Groundwater Transfer Review Summary Form

Transfer/PA # T- 13598 (RA)

Application: T-13598

-
1. Basic description of the changes proposed in this transfer: Applicant proposes to transfer 5.5 acres of POU and both POA under **Certificate 94783***, which currently authorizes Nursery Use on 62.4 acres at a maximum rate of 0.56 cfs in any combination from “Well 1” (**CLAC 784**) and “Well 2” (**CLAC 777**), with a further limitation on the individual rate from “Well 2” of no more than 0.54 cfs. The proposed To-POA are within ~550 ft of authorized “Well 2” (**CLAC 777**) and are yet to be constructed. The authorized From-POA and -POU as well as the proposed To-POA and -POU are within the Damascus Groundwater Limited Area.

Well Location Map

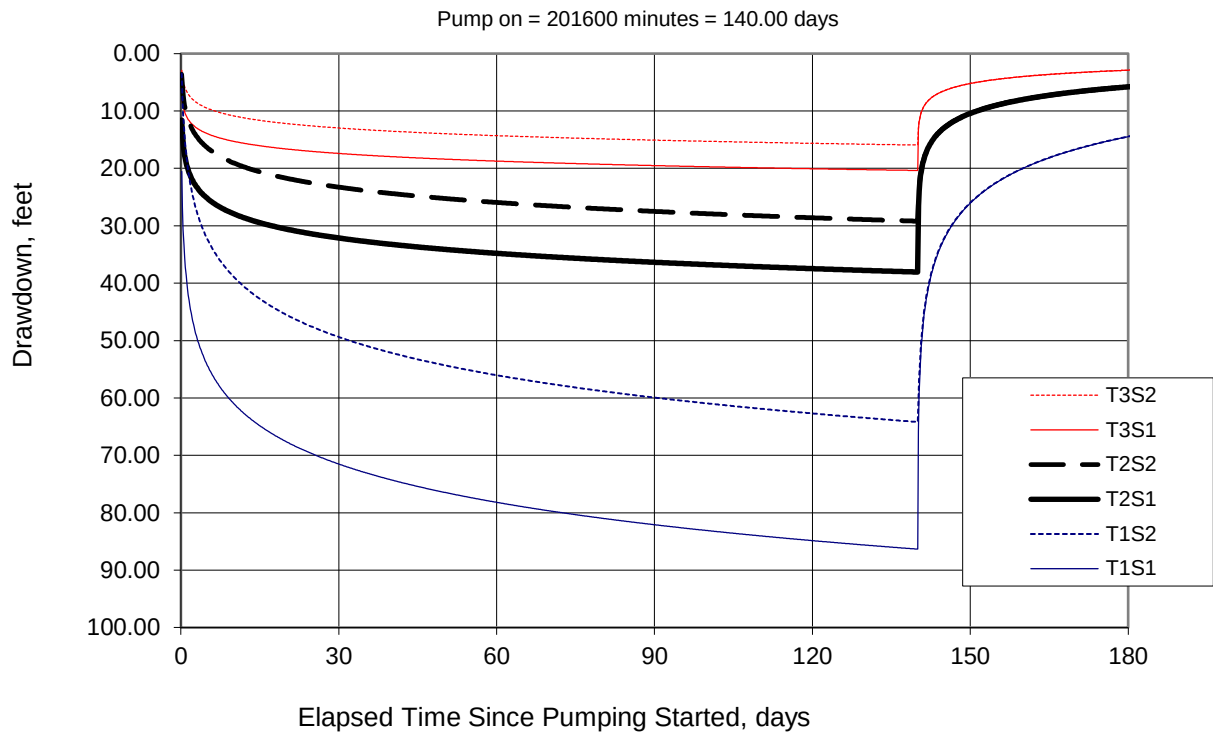
4. a) Will this proposed change, at its maximum allowed rate of use, likely result in an increase in interference with **another ground water right**?
☒ Yes ☐ No Comments: Proposed To-POA "Well 3" would be ~400 ft east of neighboring well CLAC 791, an authorized POA under Certificates 83290* and 88108* which is completed to a similar depth as the proposed To-POA. The closest From-POA, "Well 2" (CLAC 777), is ~700 ft from CLAC 791. The reduced intervening distance would likely cause an increase in interference with CLAC 791.

- b) If yes, would this proposed change, at its maximum allowed rate of use, likely result in another groundwater right not receiving the water to which it is legally entitled?
☐ Yes ☒ No If yes, explain: A Theis (1935) drawdown analysis was used to estimate the interference with CLAC 791 as a result of the proposed change. To provide a conservative analysis, it was assumed that proposed To-POA "Well 3" would pump continuously at the maximum allowable rate (0.56 cfs) up to the maximum allowable volume (156 af/yr) under Certificate 94783*, projected to take ~140 days. Results of the analysis indicate that although the interference between proposed To-POA "Well 3" and CLAC 791 may be substantial, it is unlikely to deprive CLAC 791 or similarly-located wells of groundwater to which they are legally entitled (see attached Theis Drawdown Analysis).
